Reference: Notice of Alteration - Headingley Wastewater Treatment Facility (Licence No. 2869 RRR)

File No. : 111220795	Environment Act Licence No. : 2869 RRR	
Legal name of the Licensee: RURAL MUNICIPALITY OF HEADINGLEY		
Name of the development: Headingley Wastewater Treatment Facility Upgrade		
Category and Type of development per Classes of Development Regulation: Waste Treatment and Disposal <SELECT>		
Licensee Contact Person: Sandra Miller, Chief Administrative Officer Mailing address of the Licensee: 1-126 Bridge Road City: Headingley Province: MB Postal Code: R4H 1G9 Phone Number: (204) 837-5766 Fax: Email: smiller@rmofheadingley.ca		
Name of proponent contact person for purposes of the environmental assessment (e.g. consultant): Brett Ransom, P.Eng., Stantec Consulting Ltd.		
Phone: (204) 981-2826	Mailing address: 500-311 Portage Ave, Winnipeg, MB	
Fax:		
Email address: brett.ransom@stantec.com		
Short Description of Alteration (max 90 characters): WAS piping, redundant blowers upgrade, centrifuge monrail, splitter box access

4 Headingley WWTF Improvements

MANITOBA WATER SERVICES BOARD
HEADINGLEY WASTEWATER TREATMENT
FACILITY UPGRADES

WAS PIPING CHANGES

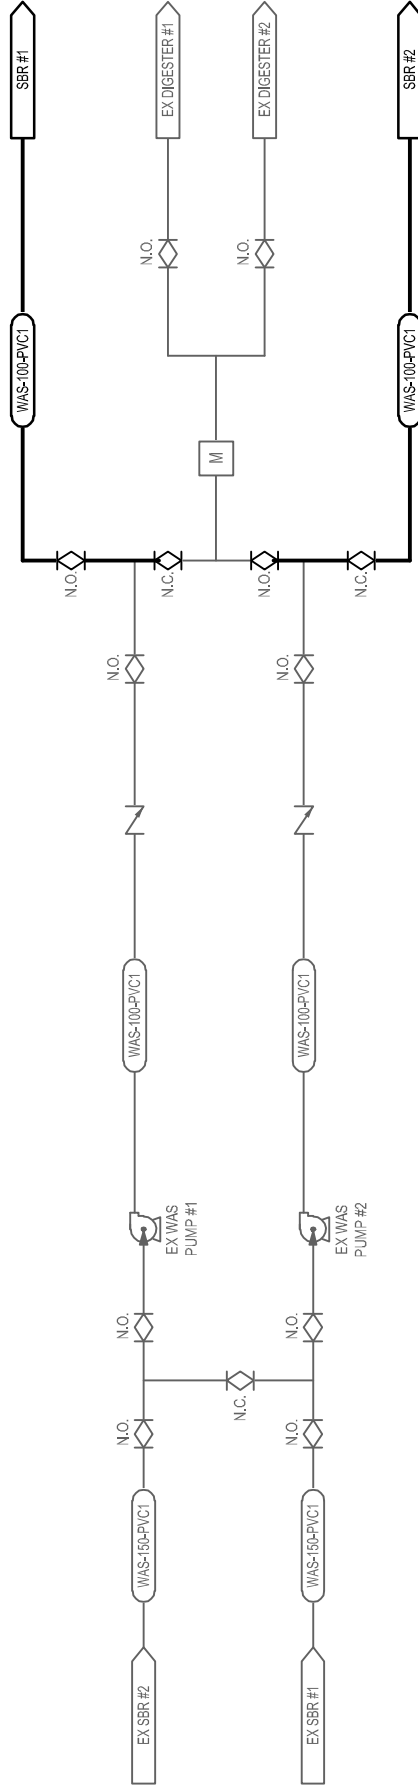
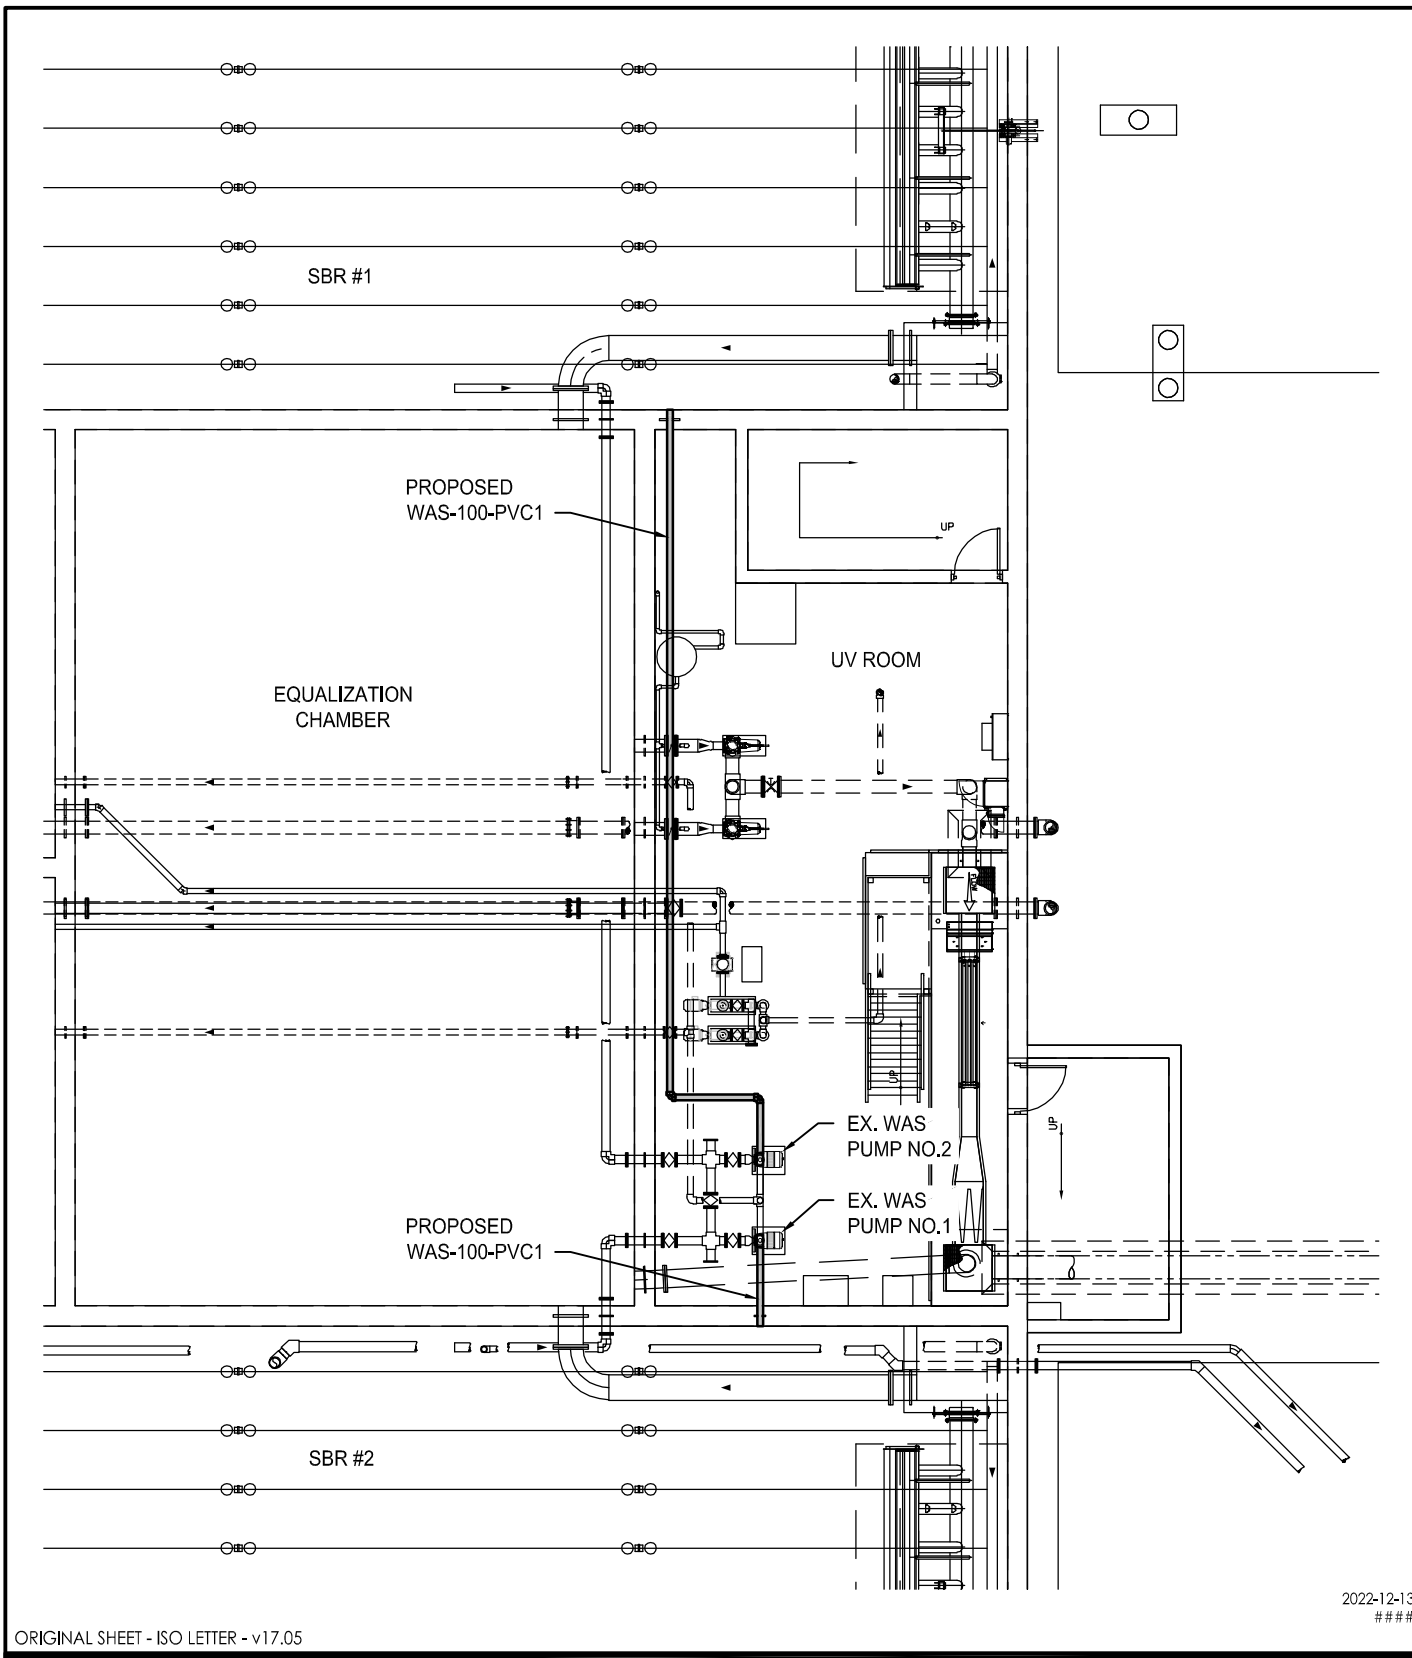
It would take approximately 49 hours of pumping using the WAS pump to transfer the content of one SBR to the other. It is proposed to modify the discharge piping downstream of the WAS pumps to allow for discharging to the decanter end of the SBR. While piping to the pre-react zone would be preferred, discharging to the decanter end is acceptable from a process standpoint so long as the SBR cycle is in the aeration or mixing mode. Refer to **Figure 4-1** for the current piping configuration and to **Figure 4-2** and **4-3** for the proposed piping modification. Note that the valve positioning in **Figure 4-2** is for transferring from SBR No. 2 to SBR No. 1.

REDUNDANT BLOWERS

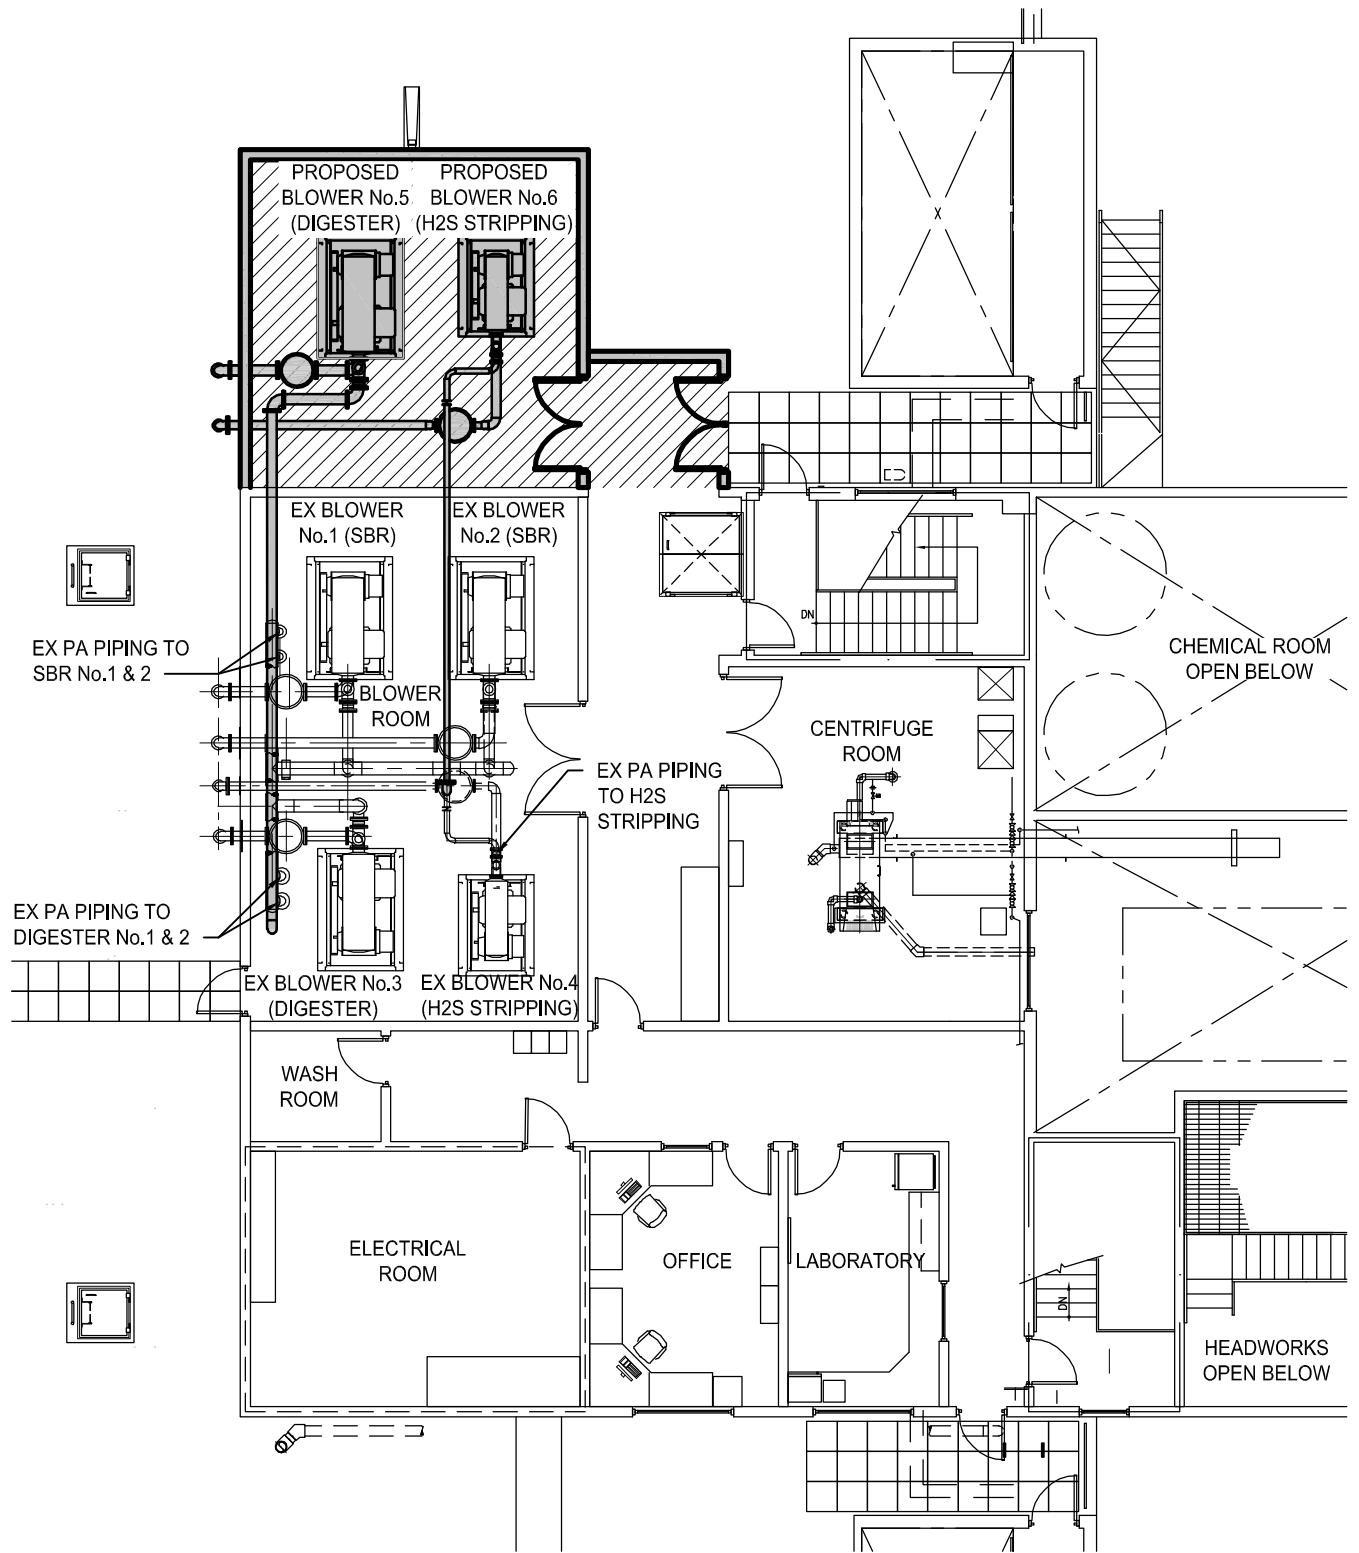
The characteristics of the existing Digester and H₂S Stripping Tank Blowers are summarized in **Table 4.1**. It is proposed to add redundant blowers to match the existing blowers. Refer to **Figure 4-4** for the proposed piping configuration for the redundant blowers.

Figure 4-6: Centrifuge Room

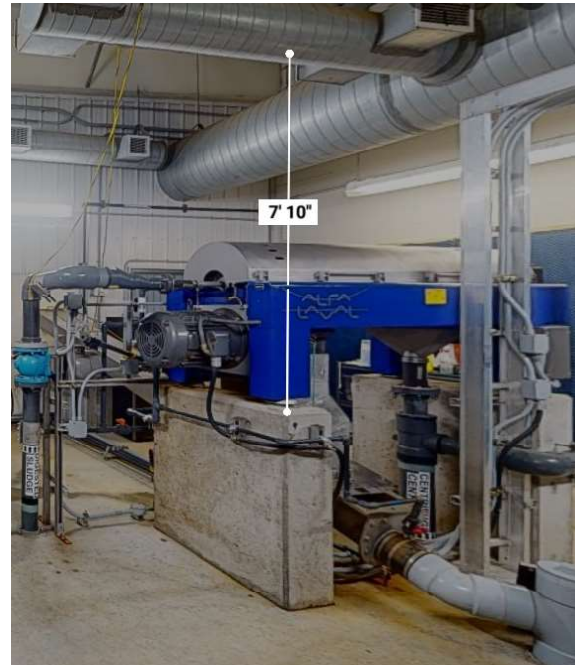
The installation of a monorail beam above the centrifuge is complicated by ducting installed over the unit. Refer to **Figure 4-6** for an image of the centrifuge installation. There is currently 2,387 mm of space between the 355 mm diameter branch duct and the centrifuge base, while a minimum of 1,500 mm of space is required between the monorail hoist hook and the base. When a monorail beam (381 mm) and 2 tonne hoist (540 mm) are added there is not sufficient space between the duct and the base.

It is proposed to relocate the 355 mm diameter branch duct south and install a 2-tonne monorail beam above the main 812 mm diameter duct. Refer to **Figure 4-7** for a plan view of the proposed monorail.
